SPINDLE & SEALS KIT 1112629700 for TANKFLY™ butterfly valve Flanged & Clamped

Tankfly Spindle Seals assembly according PEROLO Serial Number

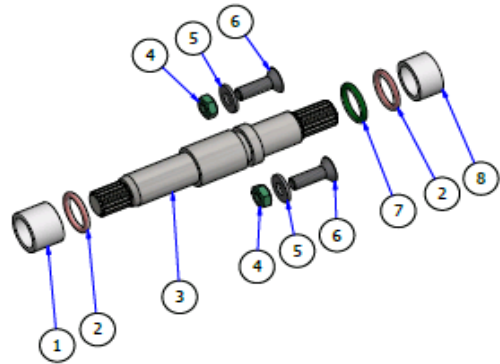
PREVIOUS ASSEMBLY

11 12 62 94 00 can replace the 2 previous assemblies with hexagonal spindle

CURRENT ASSEMBLY WITH HEXAGONAL SPINDLE

CURRENT ASSEMBLY WITH SPLINED SPINDLE

If you want to upgrade a hexagonal spindle to a splined spindle, please order spindle & spindle seals kit 1112629700, handle kit 1114859000 and closure plate kit 1285578100
